PLANNING COMMISSION STAFF REPORT

TO:	Virgin Town Planning Commission
FROM:	Ryker Steglich, Town Planner, Sunrise Engineering
DATE:	September 1, 2026
SUBJECT:	Sign Permit Application — Zion Adventures Secondary Sign, 1055 E Highway 9
MEETING:	Regular Planning Commission Meeting

Below are the manufacturer specs for the exact LED lights that will be used on this sign. They are labeled as “G2G United II 0.8watt White 4200K 12V 1.5 Mods/Ft 70 Mods/46.67’ Bag”. 130.2 Lumens per module. 195.3 Lumens per foot.

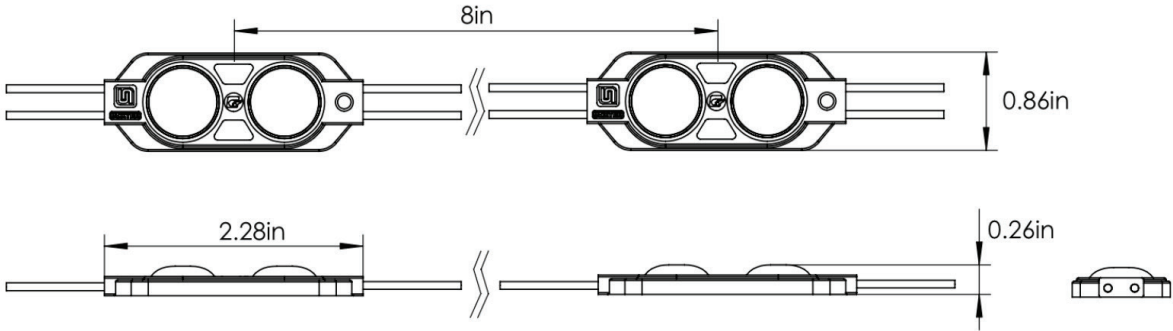
VMC §50.10(F)(3) and §50.06(C) require all sign light sources to have a color temperature no greater than 3,000 degrees Kelvin. The application as submitted specifies a 4,200K LED module, which exceeds this maximum. The applicant's own product specifications include a 2,700K option within the same module line, which conforms. Compliance with the 3,000K maximum is addressed as a condition of approval.

- Prior to permit issuance, the applicant shall provide a corrected product specification confirming that the installed LED modules do not exceed 3,000K color temperature, as required by VMC §50.10(F)(3) and §50.06(C). The 2,700K module option shown in the submitted specifications satisfies this requirement.
